Massachusetts College of Art and Design

ADA Compliance Plan 2011

ADA Compliance Plan
Consultant Services
Contract #10-08

The Institute for Human Centered Design

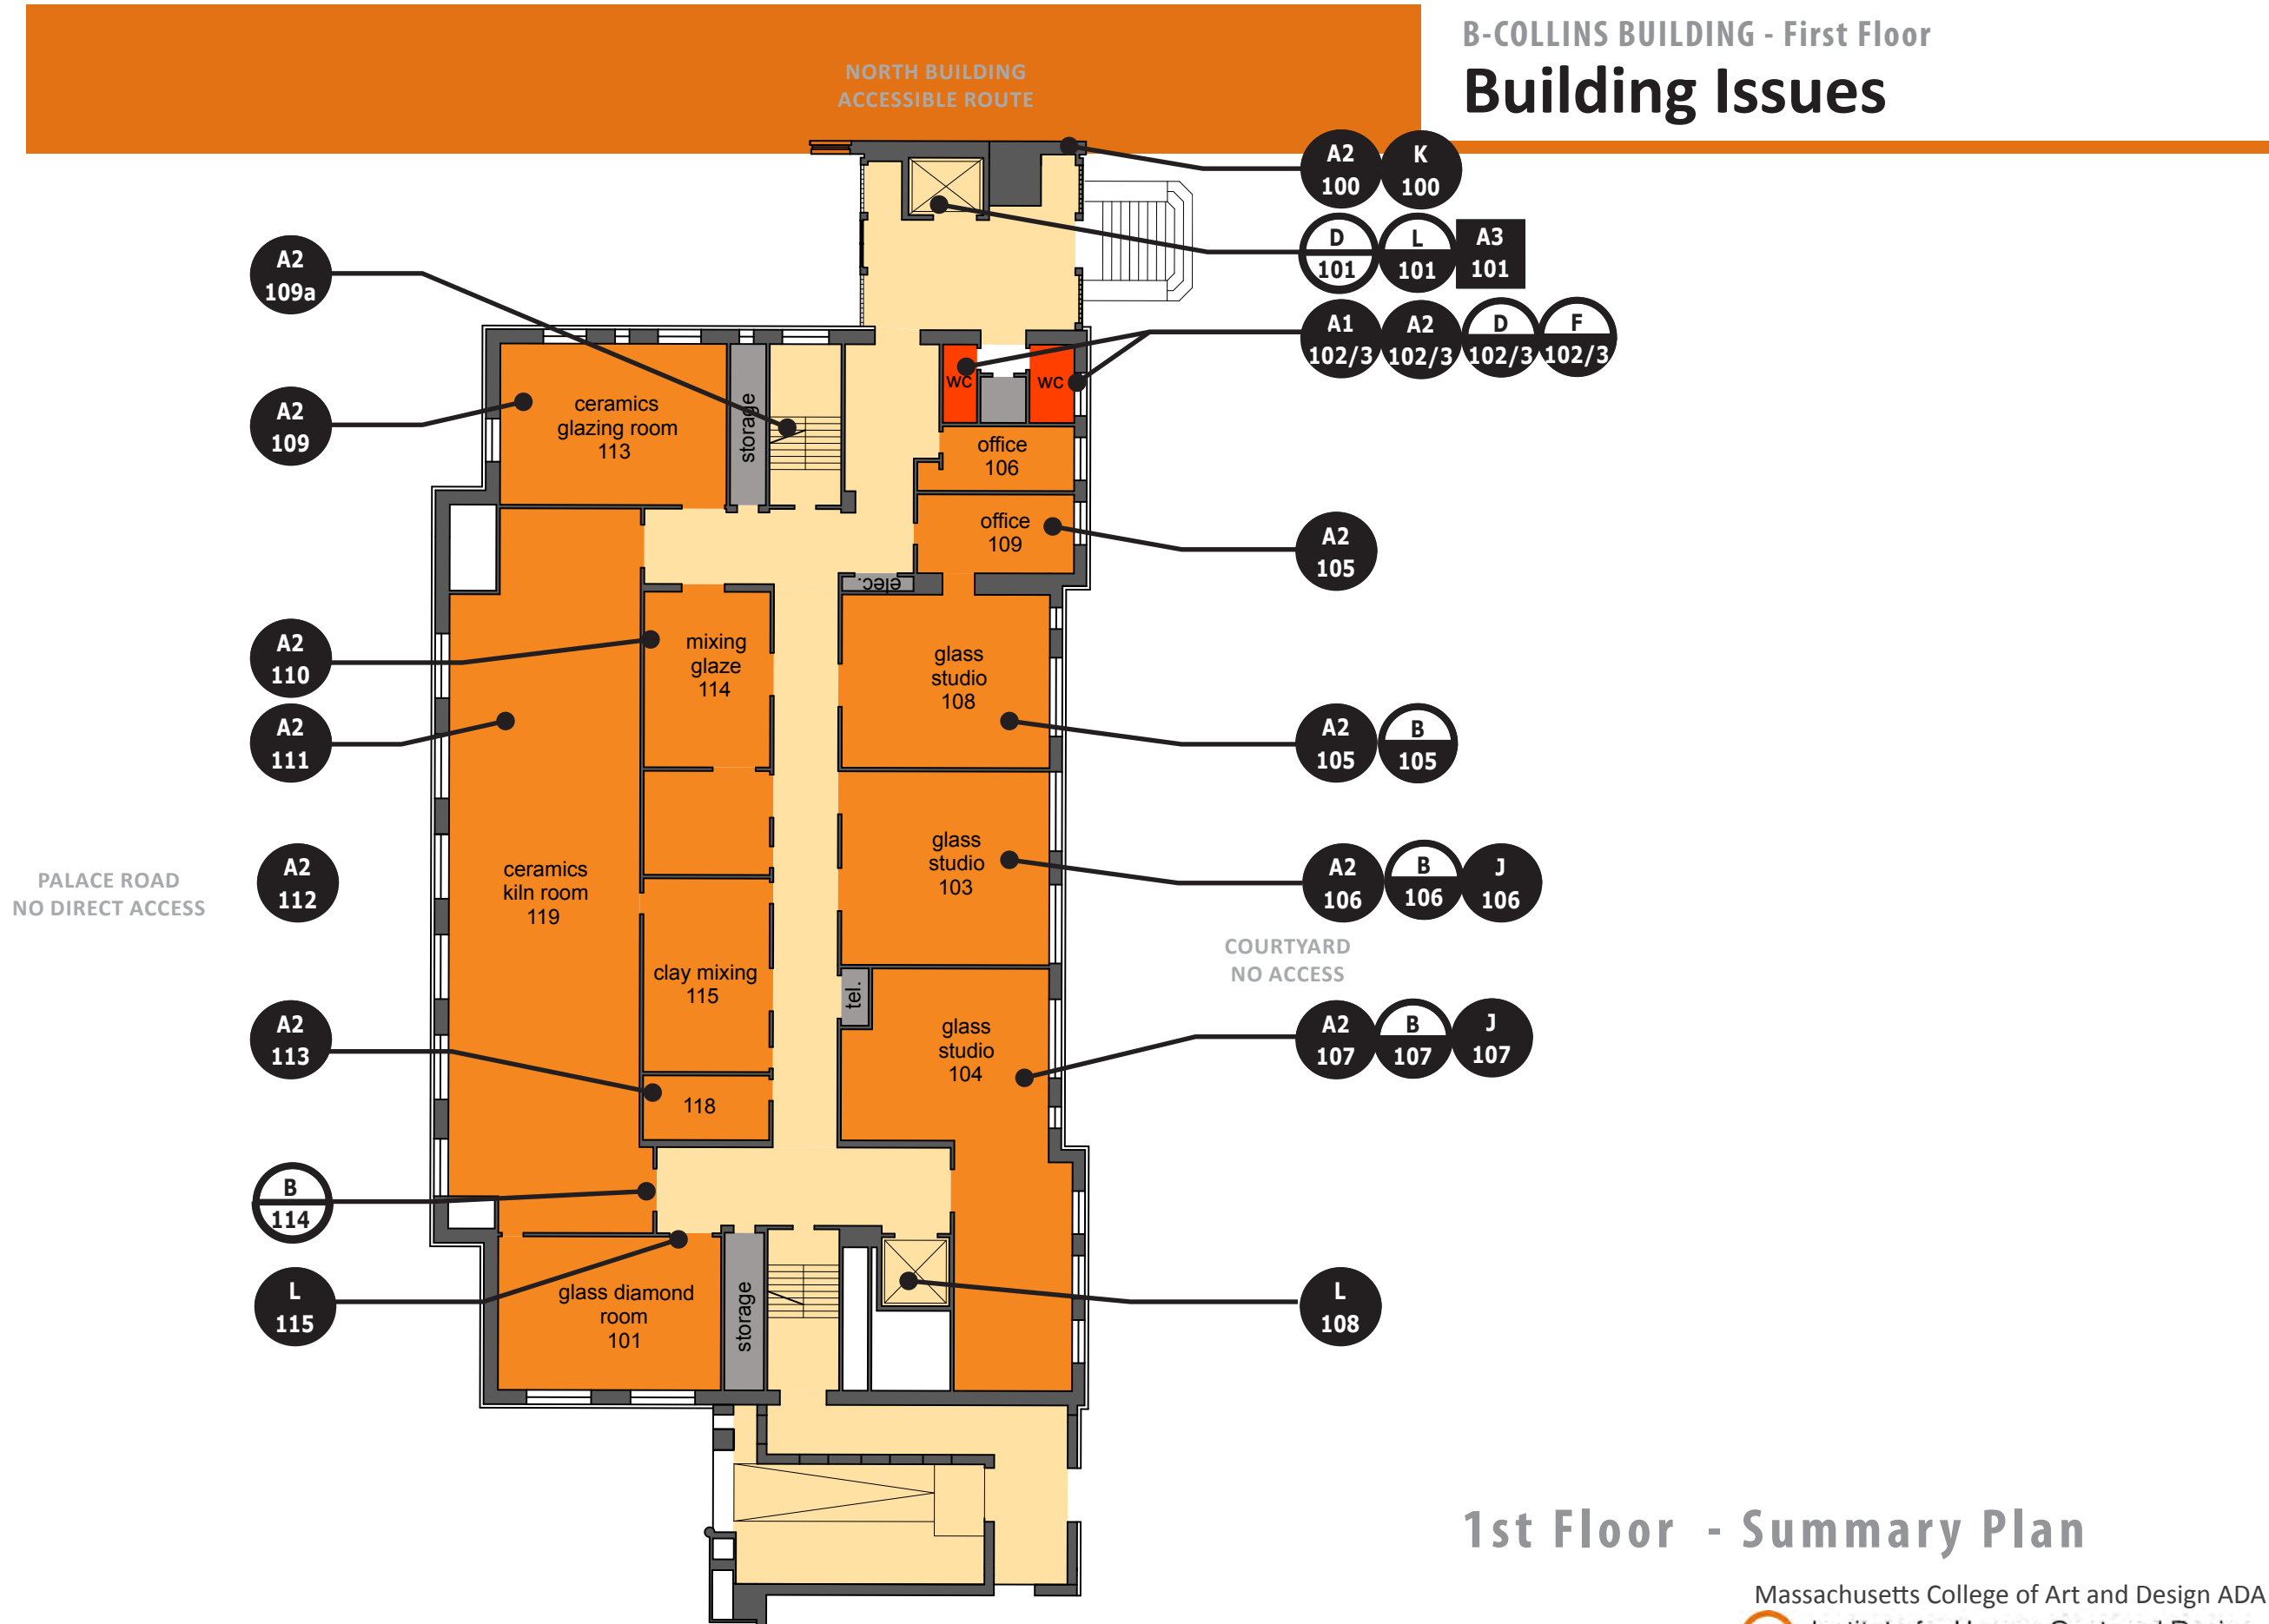
The egress stairs have no contrast between tread and riser. This makes them difficult to be discerned for people with low vision and when there is dim light. **LOCATION| B07**

RECOMMENDATION TO IMPROVE ADA COMPLIANCE

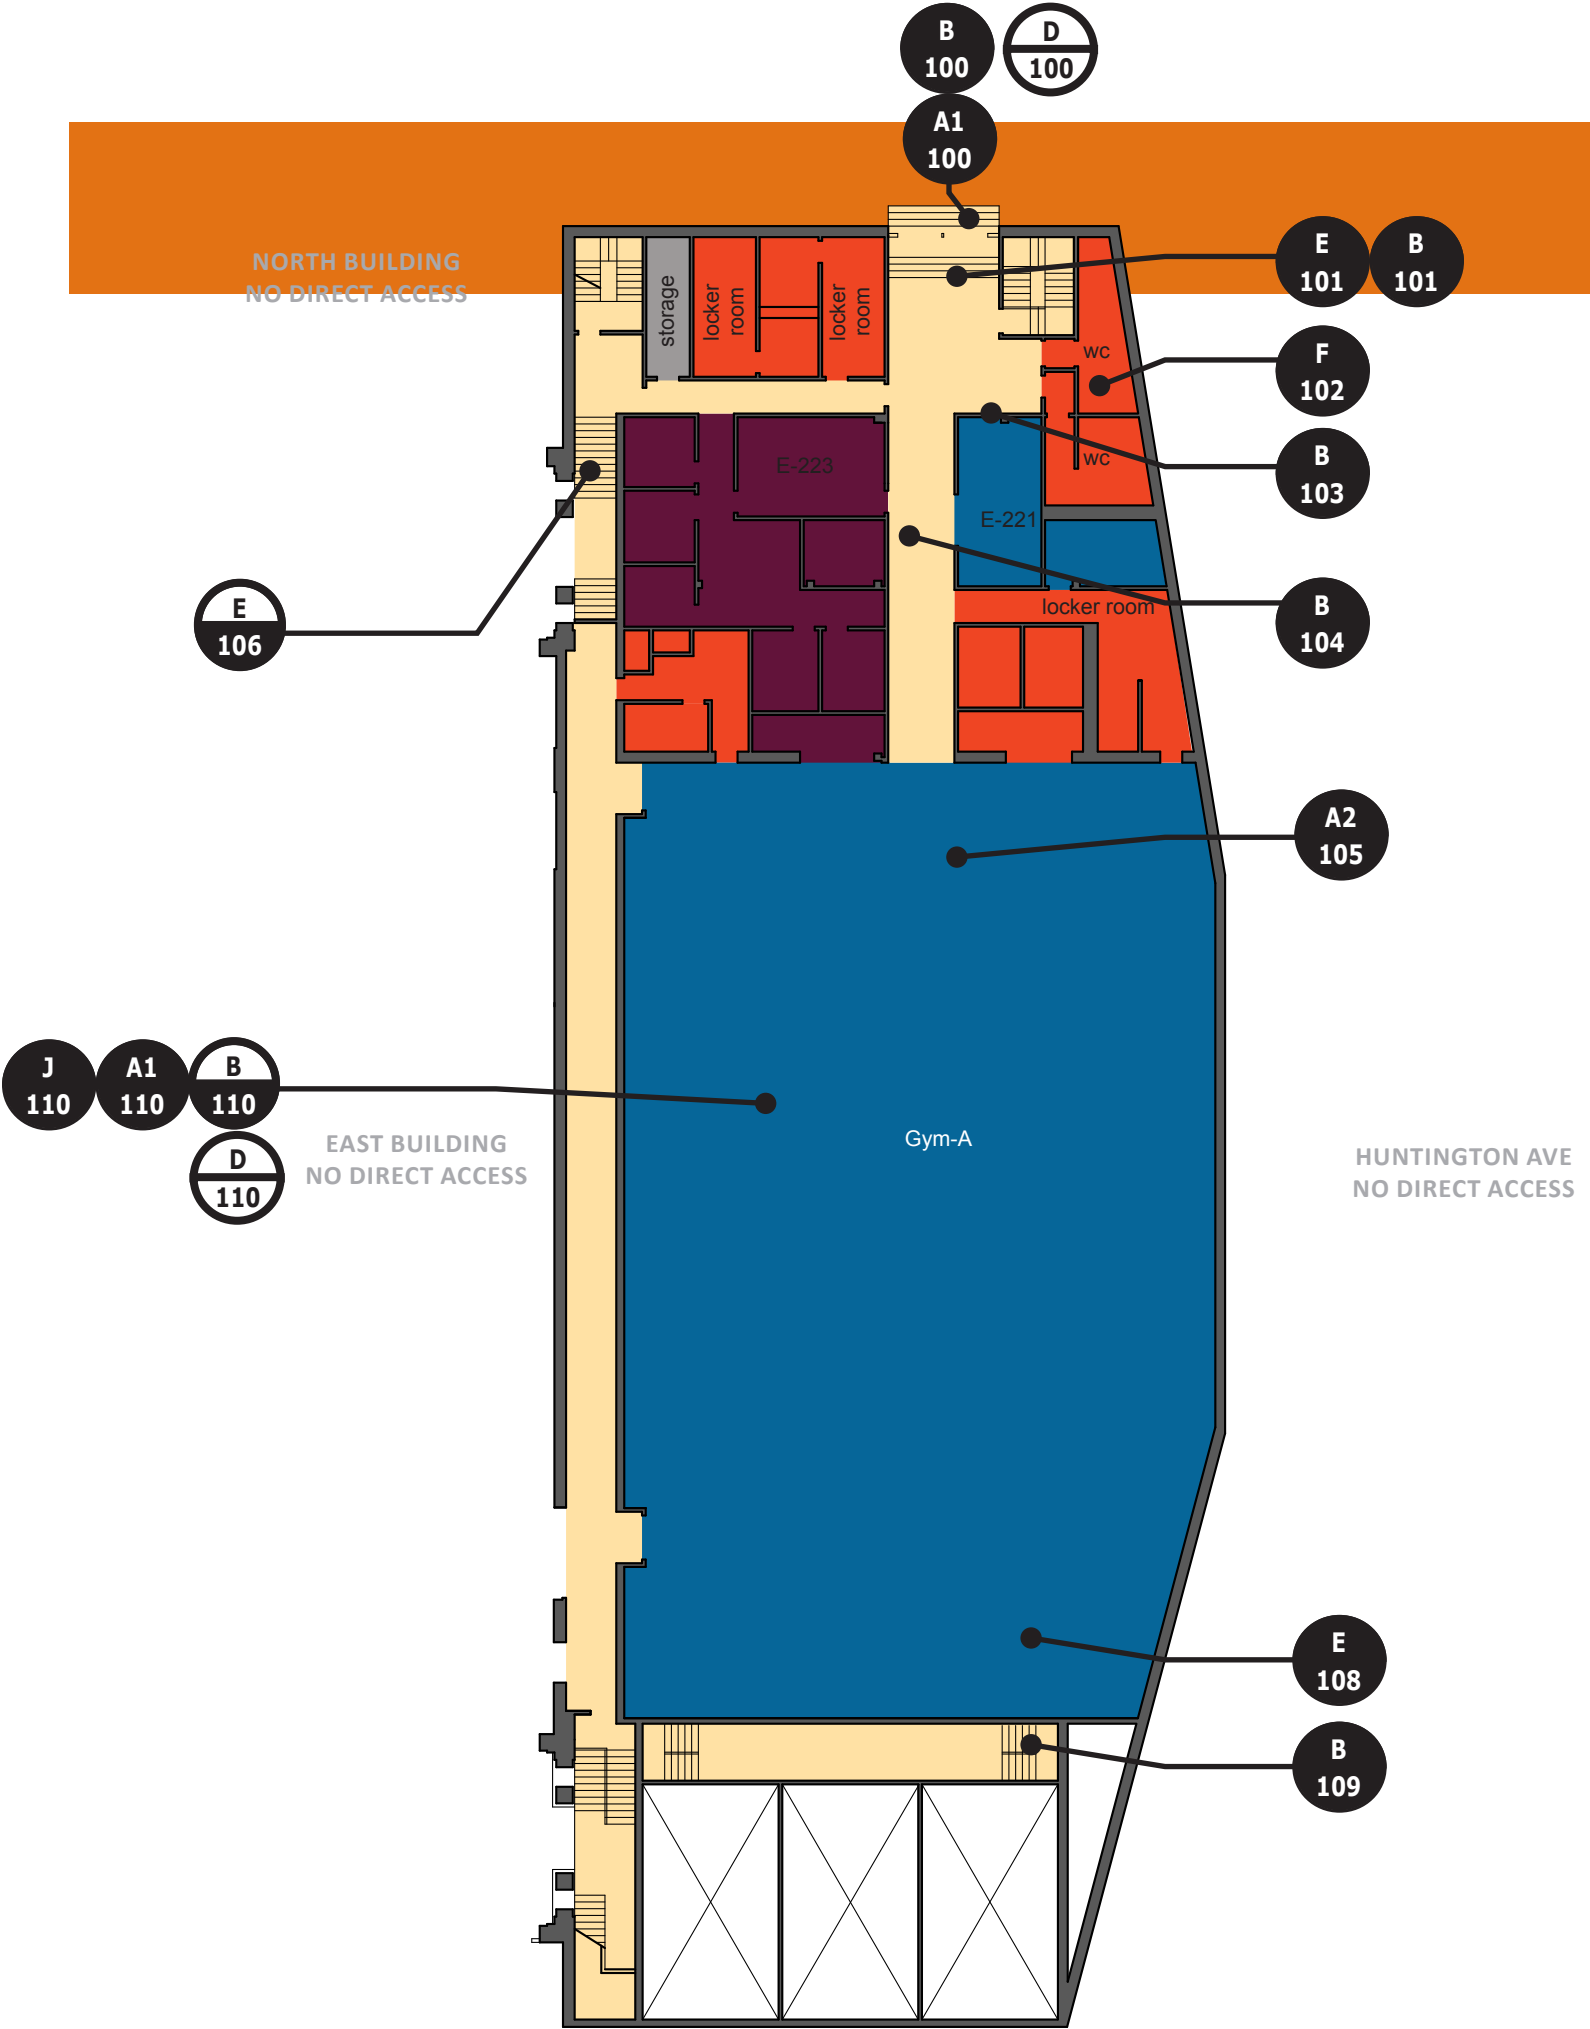
Specialized equipment is not compliant for reach ranges, controls, operational parts, and knee space clearances. **LOCATION | B06**

RECOMMENDATION TO IMPROVE ADA COMPLIANCE

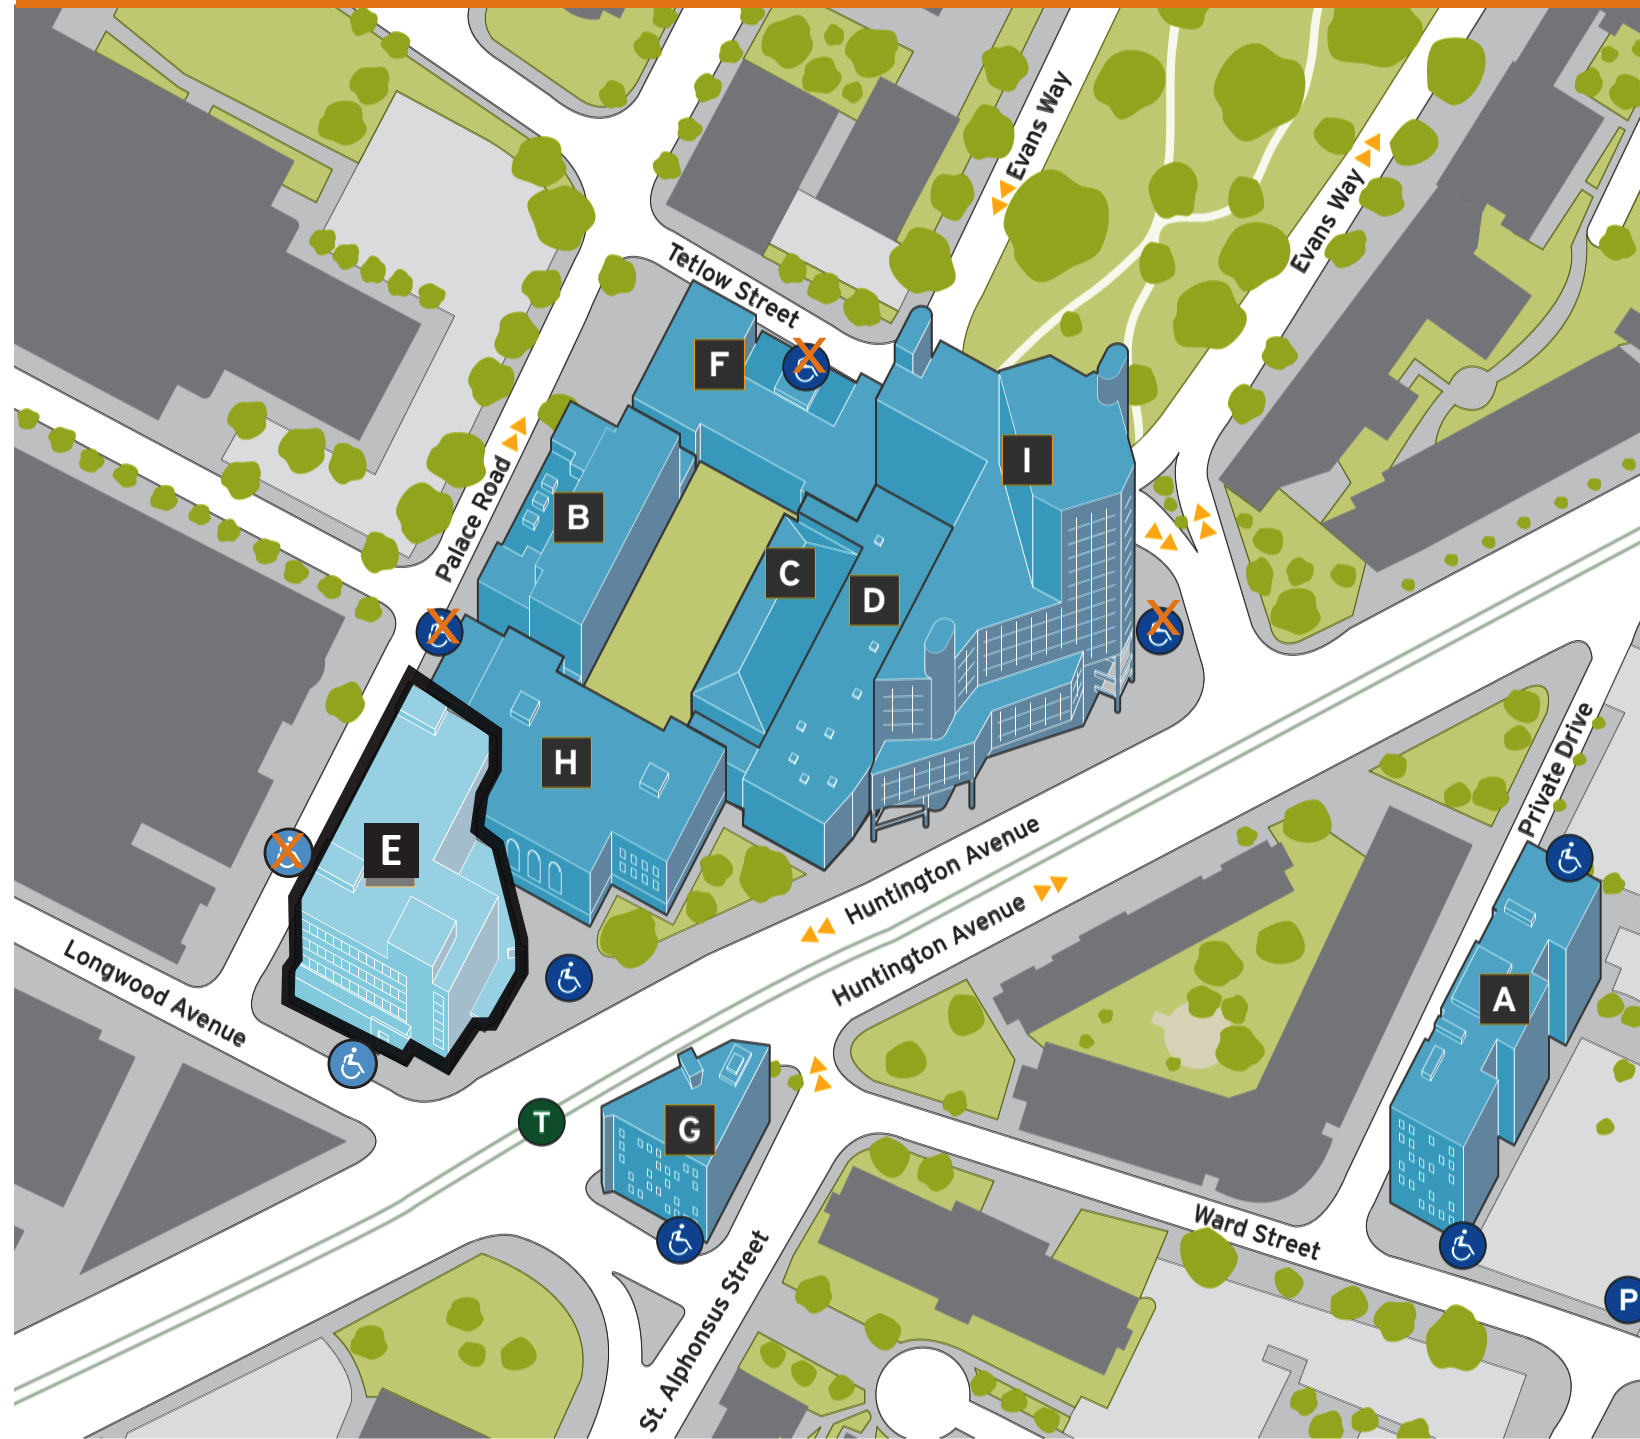
The door swing covers the landing at the stairs obstructing the stair while it is being opened. Additionally the door has glazing that is greater than 43" AFF to the bottom of the glazing panel making it difficult for a person who is short of

RECOMMENDATION TO IMPROVE ADA COMPLIANCE
